HISTORIC LANDMARKS COMMISSION

January 19, 2016
5:15 p.m. – 6:45 p.m.*
2nd Floor Council Chambers
1095 Duane Street • Astoria OR 97103

SUBJECT: REQUEST FOR NEW CONSTRUCTION (**NC15-07**) BY ED OVERBAY ON BEHALF OF OWNER TO CONSTRUCT A NEW GARAGE AT 676 IRVING AVENUE

Subject: Exterior Alteration Request (EX15-14) by Daniel Peters to rebuild exterior stairs, change one over one window to multi-lite door, replace stairs, and add a two story deck to the northwest corner elevation of existing single family dwelling located at 726 27th Street. Note: This application is in conjunction with application NC-15-08 to construct a 484 square foot garage adjacent to the house.

① SOUTH ELEVATION
SCALE 1/4" = 1'-0"

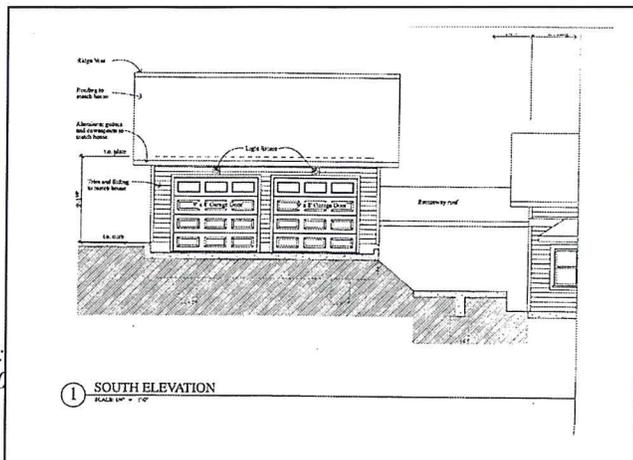
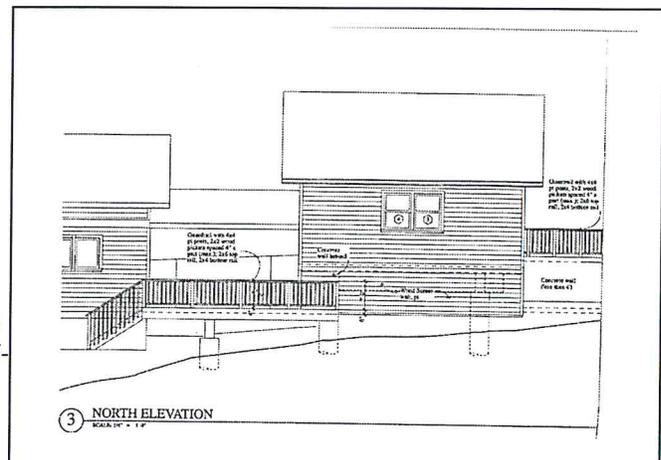
Commissioner Caruana said other than the 5.5-inch window trim, the Staff report did not mention any other details, like whether the windows would have sills, if the garage would match the house, and the style of the house. He wanted information about corner boards, window trims, fascias, and rafter tails. The Staff report stated the house was Craftsman and Cape Cod, so he wanted to know which style the garage would be. Some Cape Cods have no overhang and Craftsmans have large overhangs. He believed Mr. Overbay could do fantastic work, but he wanted to know what was being approved, especially since this application involves a variance. The garage would be 5 feet off the sidewalk instead of 20 feet. Therefore, the look of the garage from the street is important in this case. He agreed a photograph of the house would be helpful. The garage looks great, but he did not know what it would marry up to.

Commissioner Caruana said he had seen the house and liked it. The railing looked like 2 by 2s attached to the outside of a skirt board in the drawing. He asked about the railing details. A different project approved by the HLC had pressure treated material on a deck at the back of the house. He was not happy that the deck could be seen from the road. He wanted to make sure he understood the trim details on this project and asked what the balustrade and deck materials would look like.

Commissioner Caruana said he could not tell this in the picture, which looked like the 2 by 2s were just attached to the side of the skirt board along the stairs. Mr. Overbay confirmed the architect was getting around the 4-inch rule.

Mr. Overbay said answers to some of the Commissioners questions were specified in the elevation drawings. He understood the drawings were difficult to read. The siding would be smooth Hardi-plank, not wood grain, because that was already on the house. He would get the corner board dimensions and specific wrap dimensions. The guardrail would be 2 by 2 wood pickets spaced 4 inches apart with a 2 by 4 bottom rail.

Site plans: proposed windows to match existing double hung wood frame windows on house

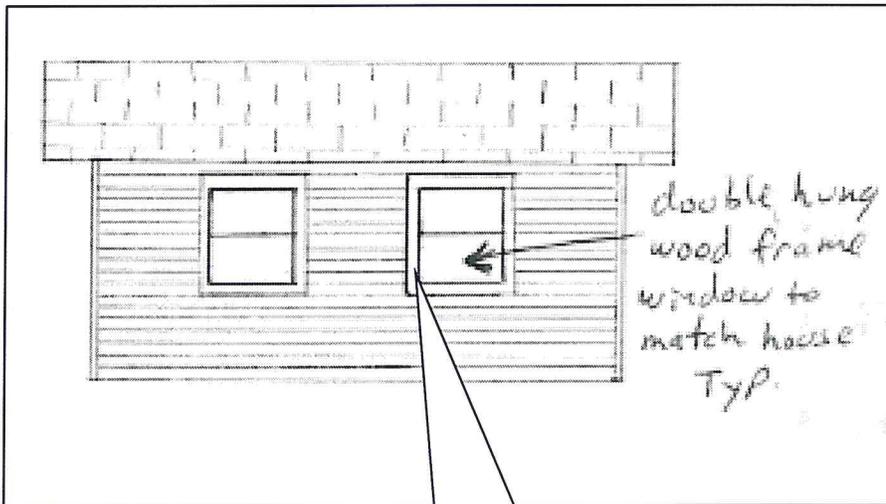
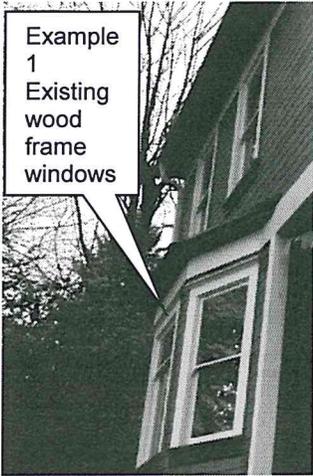
Windows in the garage door are proposed to be multi-lite, and shall have external muntins, or be true divided (Condition 1).

The windows should be installed inset similar to a historic depth so that the windows do not protrude beyond the plane of the facade as indicated in figure 2 (Condition 2)

1. Windows in the garage door shall have external muntins, or be true divided.
2. The windows shall be installed inset similar to a historic depth so that the windows do not protrude beyond the plane of the facade.
3. Significant changes or modifications to the proposed plans as described in this Staff Report shall be reviewed and approved by the Historic Landmarks Commission.

North Elevation Scale $\frac{3}{16}'' = 1'$

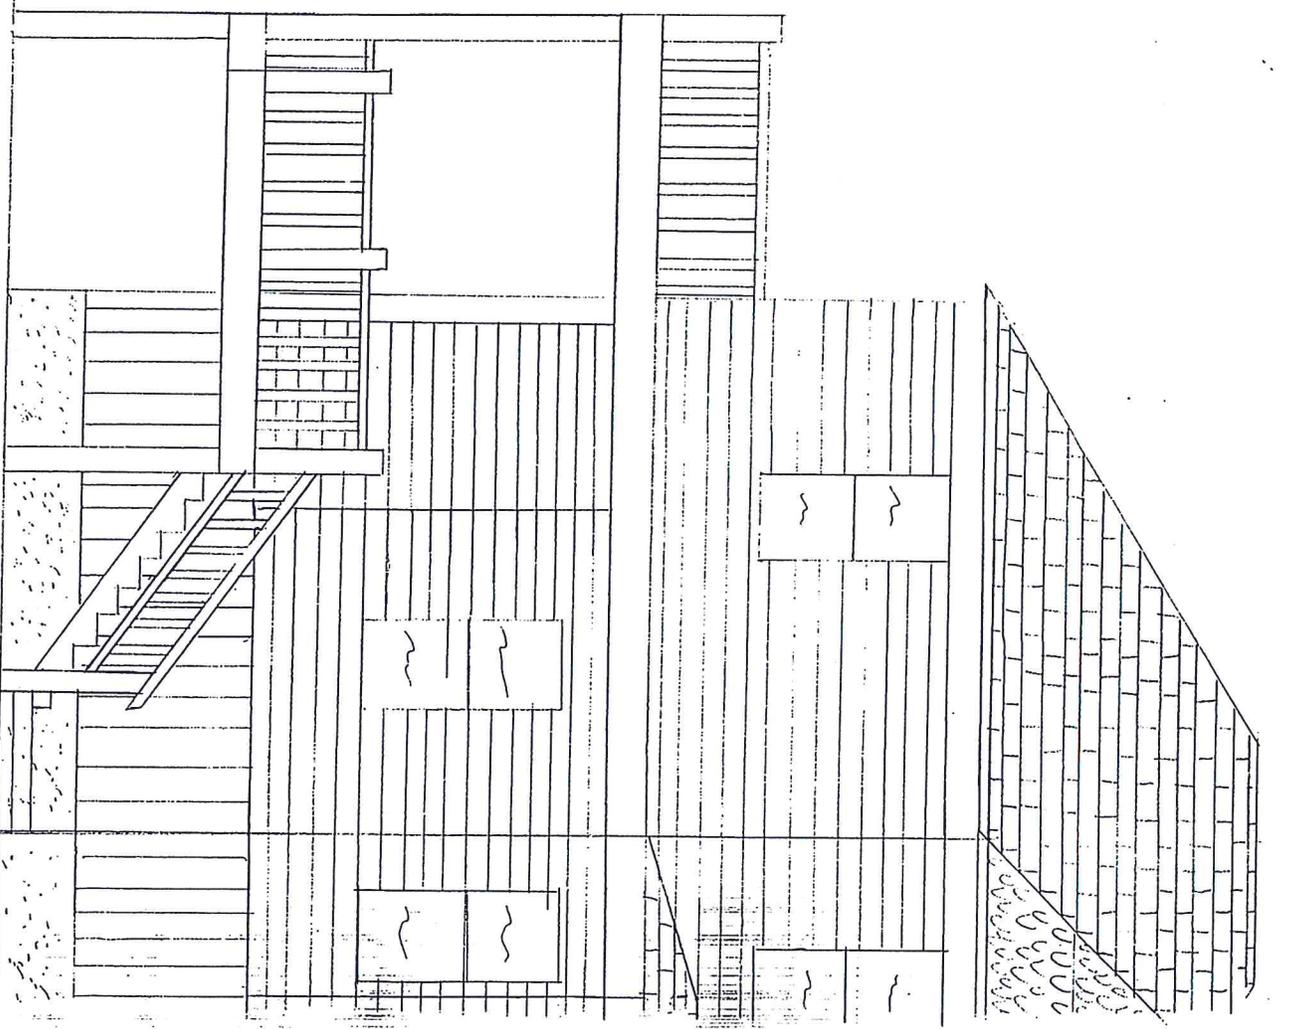
Finding: The north elevation is very visible, and is the front of the structure. The Queen Anne style typically had front porches located under the roofs, and not projecting from the house. The owner is requesting to extend the porch 8’ beyond the front façade. Due to the location on the primary façade, a protruding front porch does not maintain character of the Queen Anne style. A porch within the existing roofline, and wrapping around to the west elevation with stairs to the existing landing, would be similar to the original design and is appropriate. The extension of the front porch beyond the plane of the house should be denied. (Condition 2).

The applicant is proposing a second story deck on the primary front façade. The distinguishing characteristics of a Queen Anne style house included recessed porches, but do not include protruding decks. Therefore construction of the second story deck and the change of a window to a door on the second story is not in character with the Queen Anne style. The second story deck should be denied. (Condition 5)

1. The applicant shall remove the second story door, and replace with a one over one window.
2. The extension of the front porch beyond the plane of the house shall not be constructed.
3. Supporting posts shall be incorporated into the porch, and not exposed on the exterior. A fascia board or other cover shall hide any construction detailing.
4. The balustrade on the stairs shall have an upper and lower railing, and shall end in a newel post. The upper rail shall not extend beyond the newel post.
5. The second story deck shall not be constructed.
6. Significant changes or modifications to the proposed plans as described in this Staff Report shall be reviewed by the Historic Landmarks Commission.

2015-Door

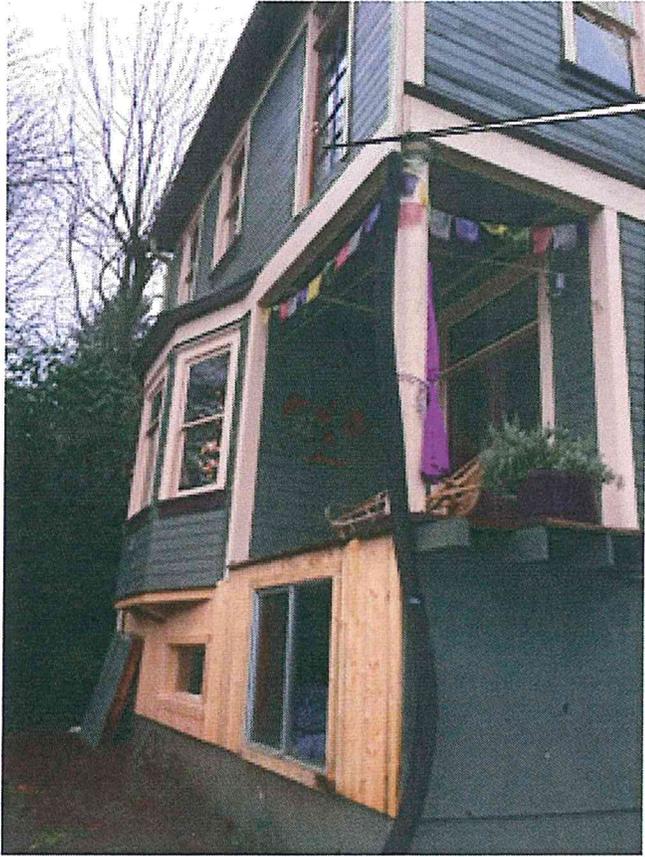
Finding: The applicant has removed a one over one window on the front second floor elevation, and replaced it with a multi-lite door.

The distinguishing characteristics of a Queen Anne style house included recessed porches, but do not include protruding decks. Therefore, removal of the historic window does not meet this criteria. Since the door has already been installed, the applicant should remove the door, and replace to the original one over one window. (Condition 1)

Since the door has already been installed, the applicant should remove the door, and replace to the original one over one window. (Condition 1)

Replacing window and door, and adding deck and stairs

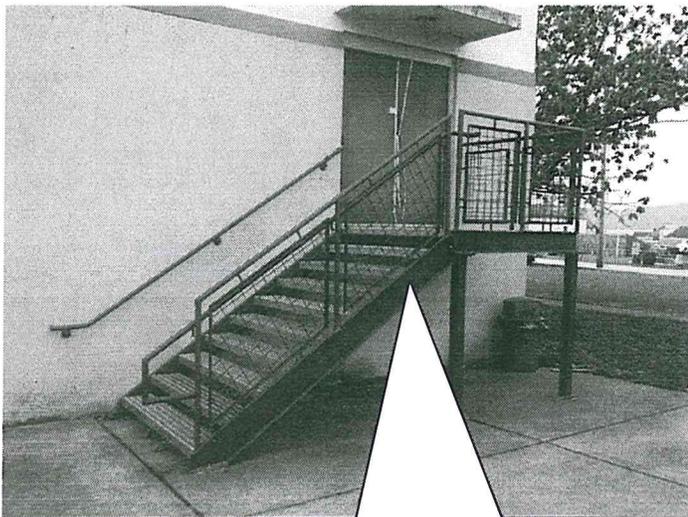
North: Replacing all windows, replacing double door with side lites with aluminum full glass door. Currently there is a boarded over steel door now, not the original door. Doors are typically a distinguishable architectural feature in this time period. The building was value engineered at the time so there is not a lot of ornamentation or extravagant features. However, the applicant should locate a photo or plans of the original door first to match before considering a contemporary design given its prominence on Duane Street and interface with the heritage district. (Condition 2)

The design is consistent with new proposed second story deck, landing and staircase to the second floor. The proposed staircase will include hot-dip galvanizing to prevent corrosion and match the existing staircase on the east elevation. The new deck will provide an area to allow guests to view the river. An awning to be installed over the door will match the awning on the east elevation.

1. When funding becomes available, all planned additional repairs of broken or boarded up windows shall be carried out with the same materials and style as the replacement and repairs described in this staff report.
2. The building was value engineered at the time so there is not a lot of ornamentation or extravagant features. However, the applicant should locate a photo or plans of the original door first to match before considering a contemporary design given its prominence on Duane Street and interface with the heritage district
